# MATANUSKA-SUSITNA BOROUGH

## **PLATTING BOARD AGENDA** **ASSEMBLY CHAMBERS** **350 E DAHLIA AVENUE PALMER**

**September 5, 2024**

TALKEETNA, ALASKA  
CORREIRA ESTATES  
SITE PLAN - DESIGN  
GRADING-DRAINAGE PLAN

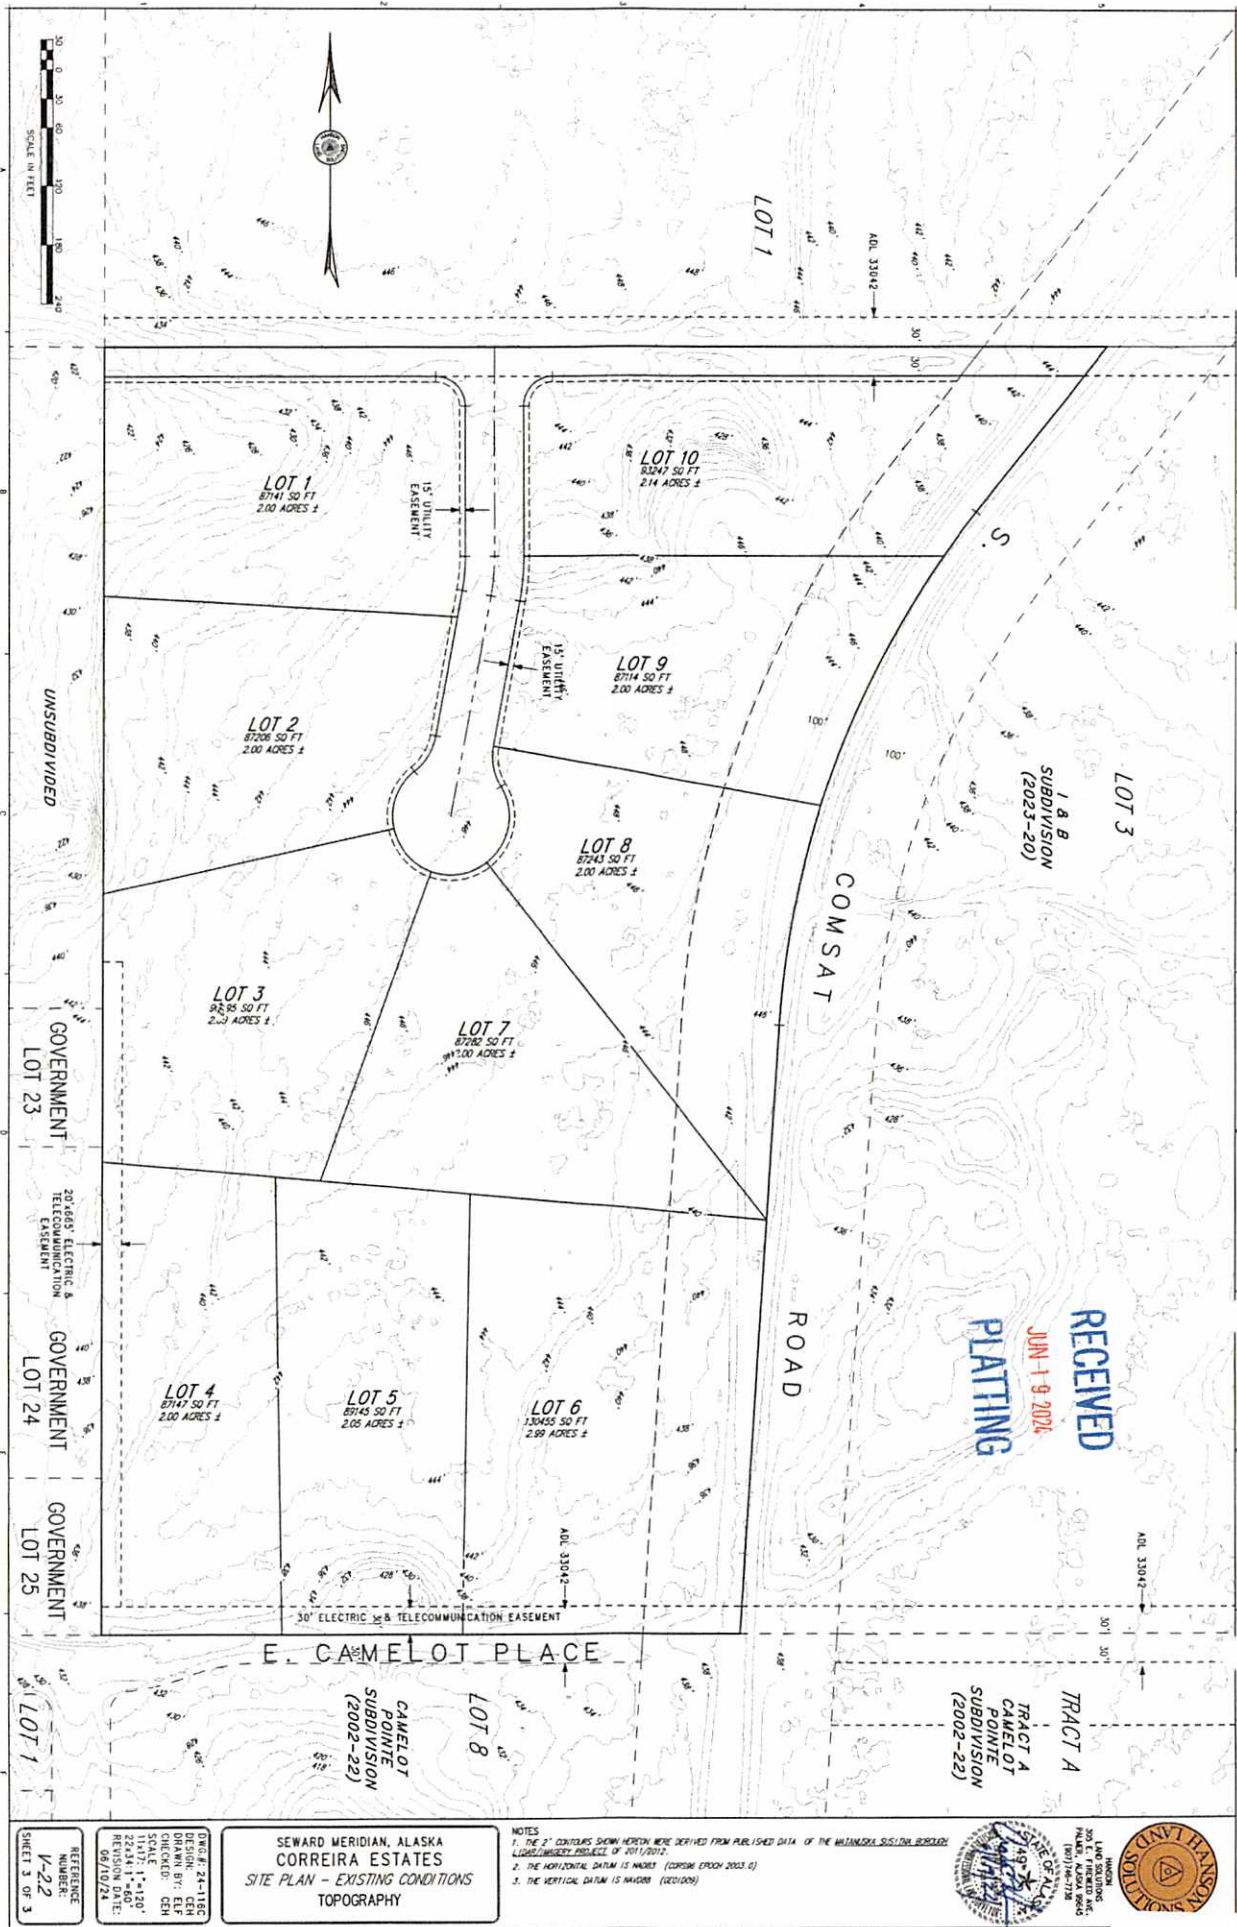
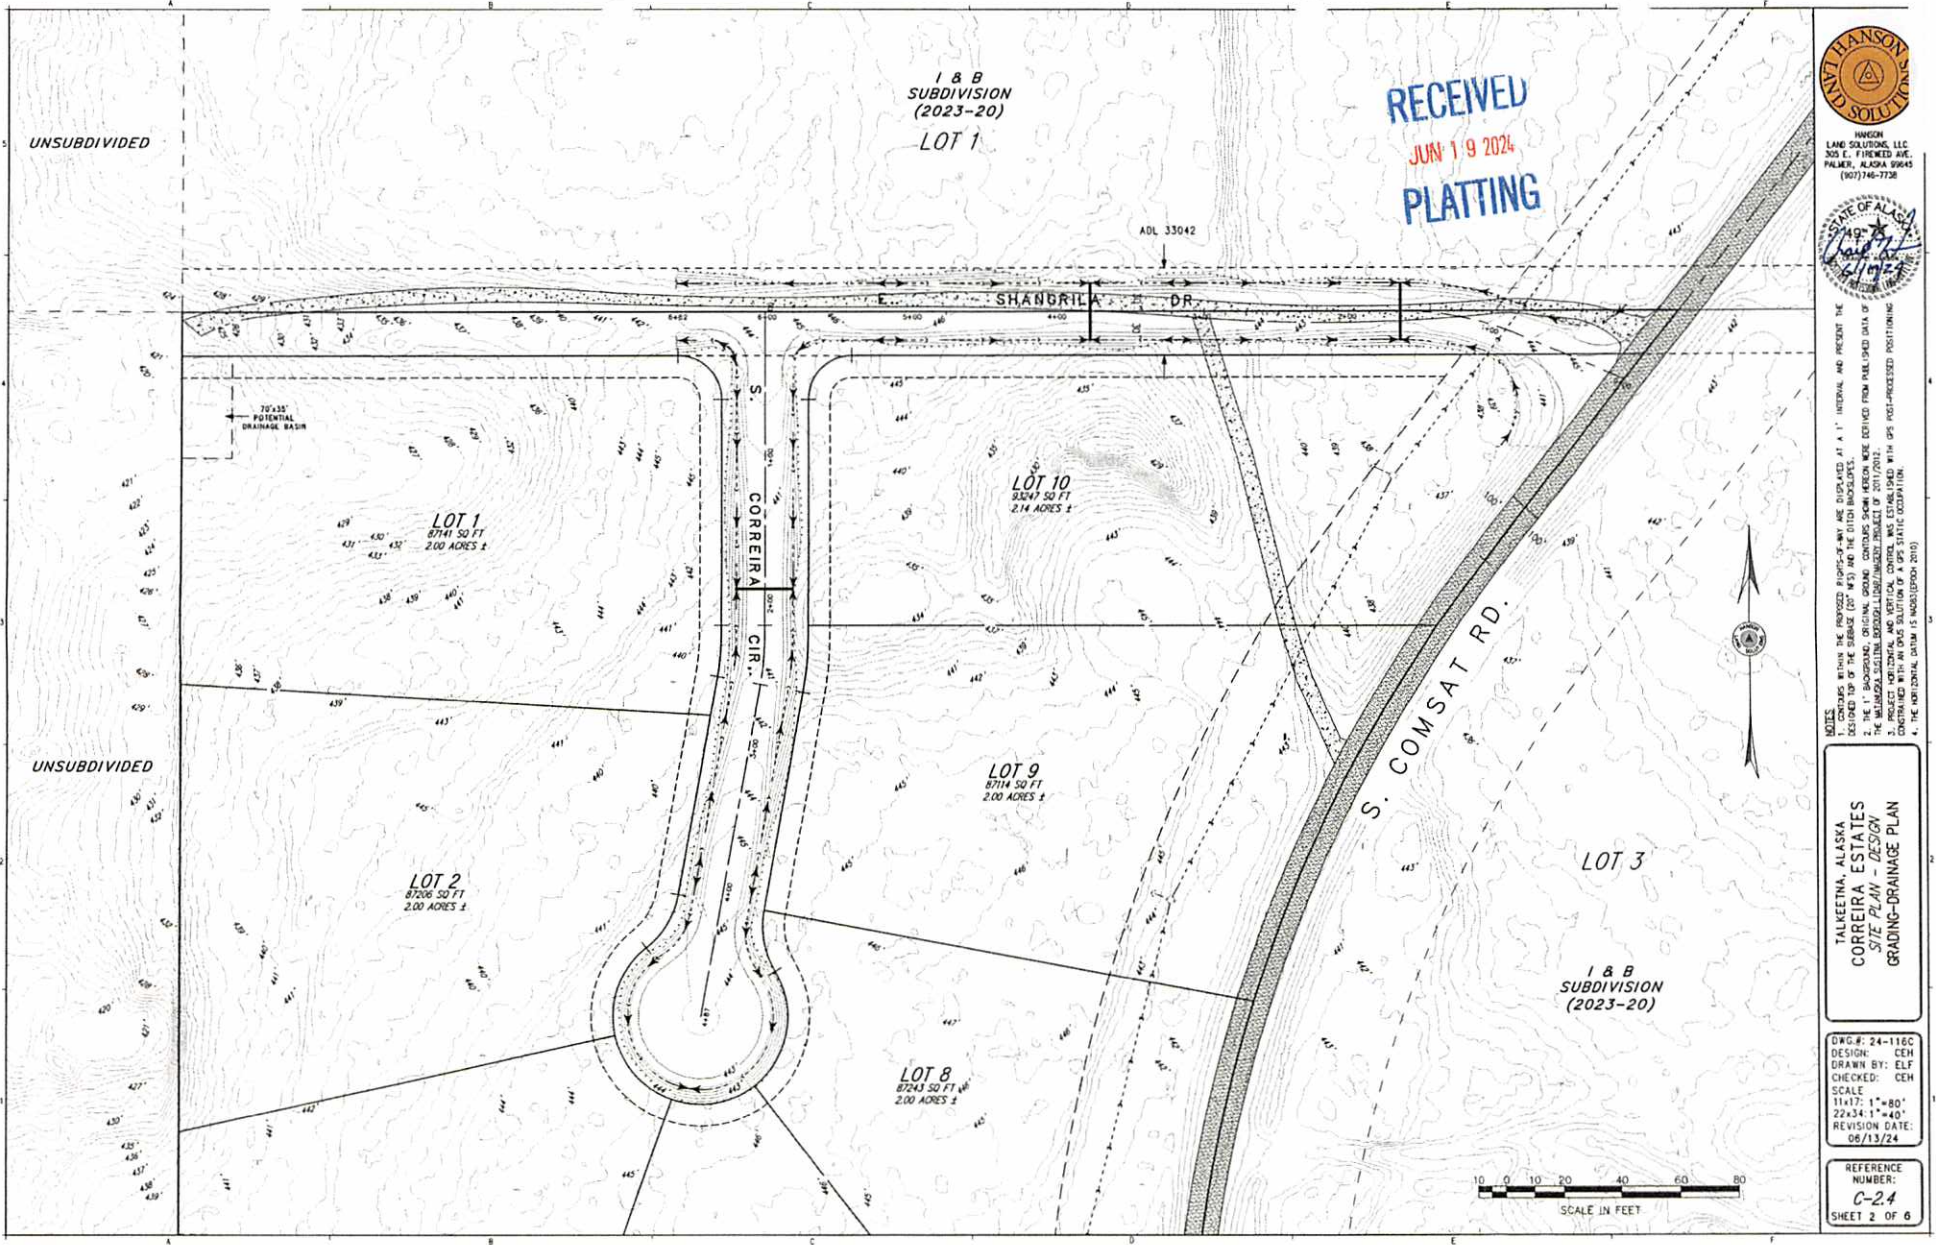
On the drainage plan, where does the runoff go after reaching the end of the cul-de-sac? Provide an outfall location for this drainage path.

Shangrila Drive and the proposed subdivision road will need to be constructed to minimum residential standards. Construct a turnaround meeting the 2022 SCM requirements at the end. Please label all easements on the plat (Comstat Road ADL, Utility Easements etc.). Dedicate minimum 15' wide utility easements along all road ROWs. On the drainage plan, where does the runoff go after reaching the end of the cul-de-sac? Provide an outfall location for this drainage path.

3. Pay postage and advertising fees.
4. Add plat notes: "No direct access for all lots to Comsat Road" & "No utility connections through Comsat Road."
5. Construct Shangrila Drive, proposed internal road, & cul-de-sac to Residential Street standard according to the 2022 Subdivision Construction Manual (SCM):

- a) Submit drainage report and other construction plans to Department of Public Works (DPW) per SCM F01.2;
  - b) Arrange preconstruction conference with DPW per SCM F01.3, sign Subdivision Construction Plan, pay inspection fee, and obtain Notice to Proceed from Platting staff;

"msb case 2024-073 ADL 33023 view 2"

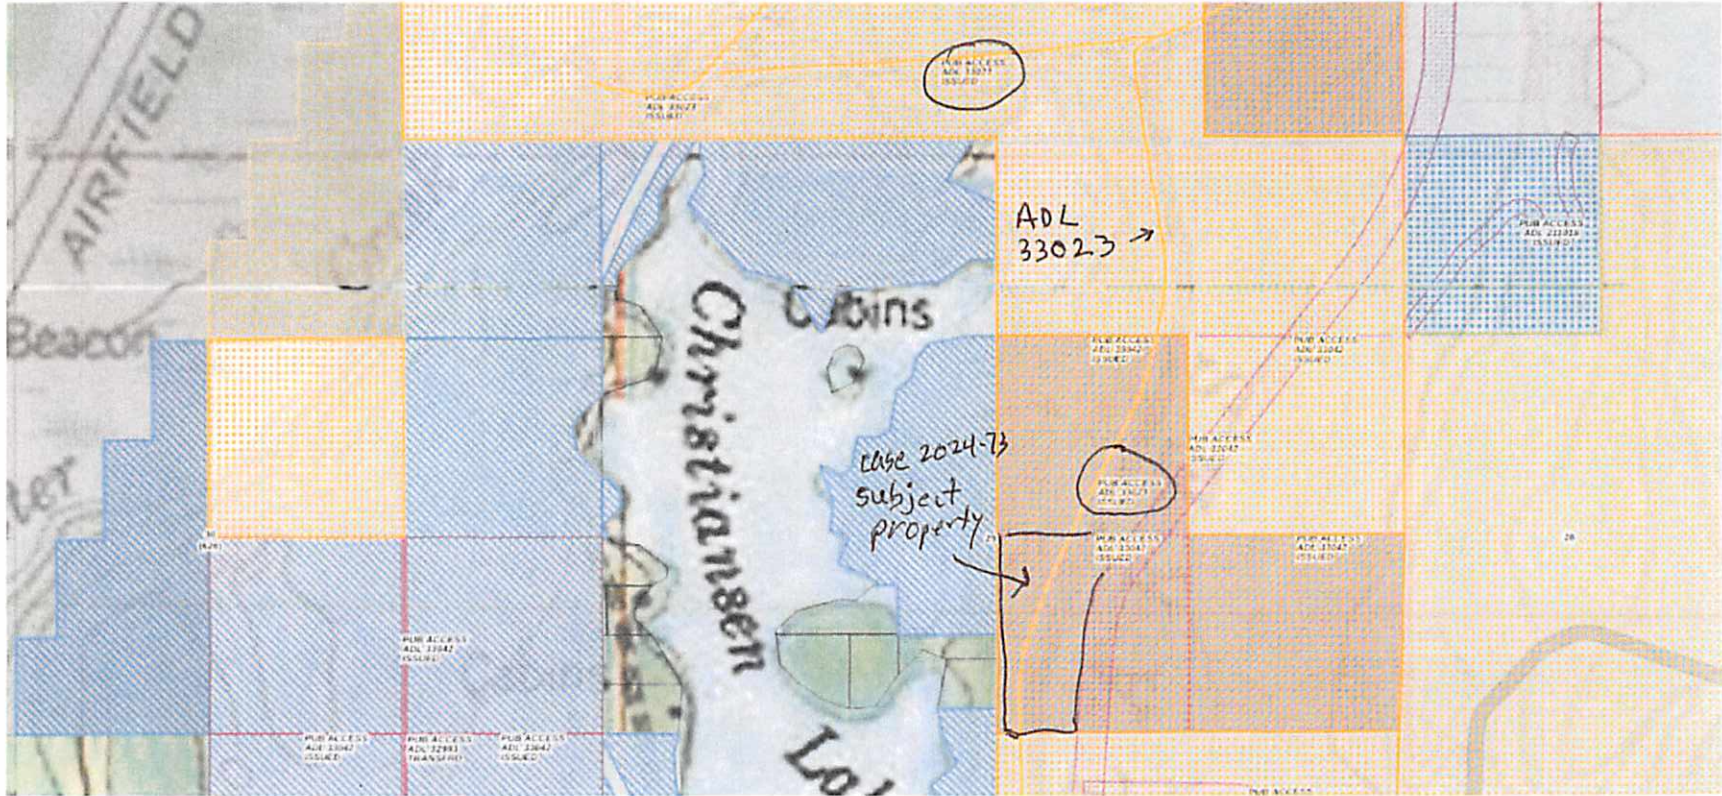
Attachments entitled "msb case 2024-073 ADL 33023.pdf" and "msb case 2024-073 ADL 33023 view 2" (both taken from the DNR website) show the subject property encumbered by ADL 33023. Note that I have annotated these two maps to point out the subject property, circle the references to ADL 33023, and clarify the reference to ADL 33042 on the maps (note ADL 33042 is shown on the Agenda Plat, yet ADL 33023 is not).

From my review of the maps and narrative found at the DNR website, ADL 33023 exists across the subject property, and therefore the public has a valid interest in this ROW. Accordingly, the plat of Correira Estates, Case 2024-073, must show this easement. Similarly, ADL 33023 runs through Lot 1 of the I & B Subdivision and that plat therefore must also show ADL 33023.

My recommendation is that the Platting Division, after conducting thorough research, and perhaps consultation with DNR, either: 1. act to properly show ADL 33023 on the Case 2024-073 plat, on other necessary documents within that case number, and on Plat 2023-20 (I & B Subdivision); or 2. in the event the State's records are found to be inaccurate or incomplete, formally request that DNR correct its records.
